7 VALVE A.W. BATTERY	
1937 MODEL BG	
RADIO (1936) LTD AUCK. N.Z.	
DRAWN	A.D.H.
CHECKED	<i>[Signature]</i>
APPROVED	<i>[Signature]</i>
DATE	28-6-37

2-volt battery
 BG
 1937

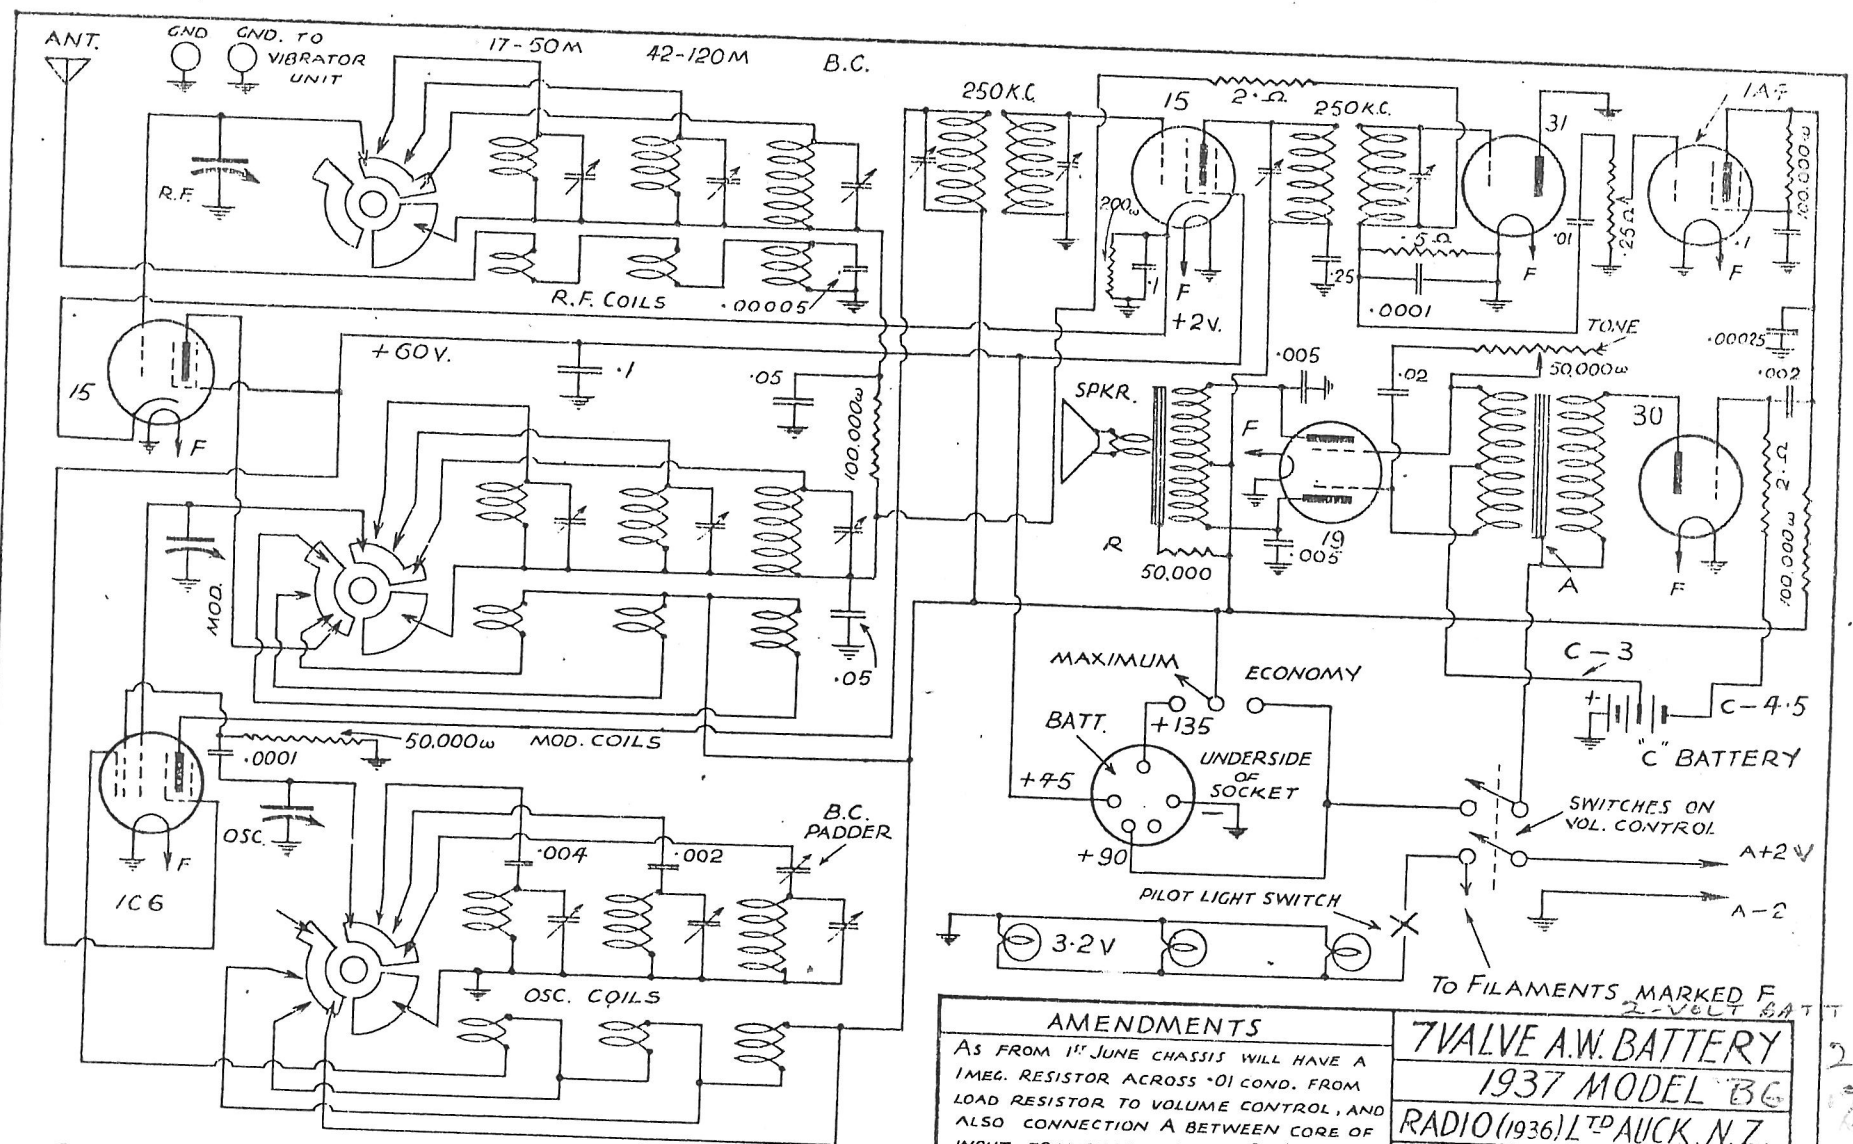
AMENDMENTS
 AS FROM 1ST JUNE CHASSIS WILL HAVE A 1MEG. RESISTOR ACROSS .01 COND. FROM LOAD RESISTOR TO VOLUME CONTROL, AND ALSO CONNECTION A BETWEEN CORE OF INPUT TRANSFORMER AND B+90 WILL BE MADE, AND RESISTOR R WILL BE INSTALLED ON SPKR.
